ST. LUCIE UNIT 1

MARKED-UP TECHNICAL SPECIFICATION PAGES

AXIAL SHAPE INDEX LIMITS EXPANSION

FIGURE 1 EXPANDED LPD L888 ASI TENT

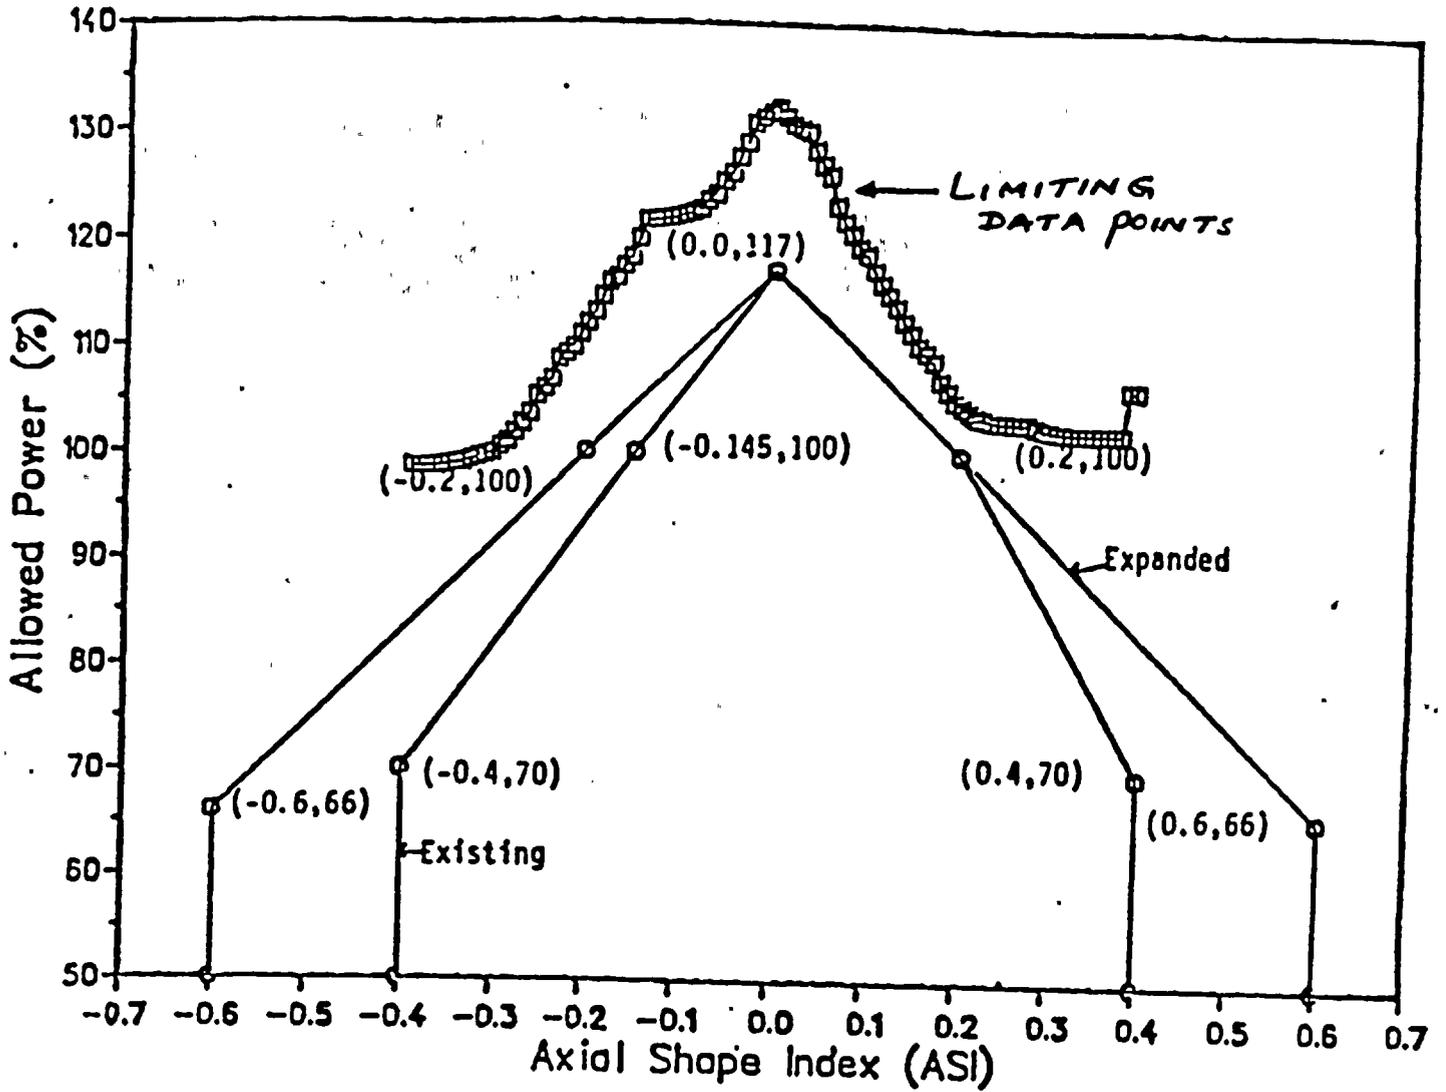
The analyses/comparisons described above showed that in all cases margin still exists between the expanded Technical Specification limits and the calculated values. Figures 1, 2 and 3, LPD LSSS, LPD LCO and DNB LCO respectively, show the existing and expanded ASI limits and the limiting data points. Figures 1, 2 and 3 show that in all the proposed cases margin is still available.
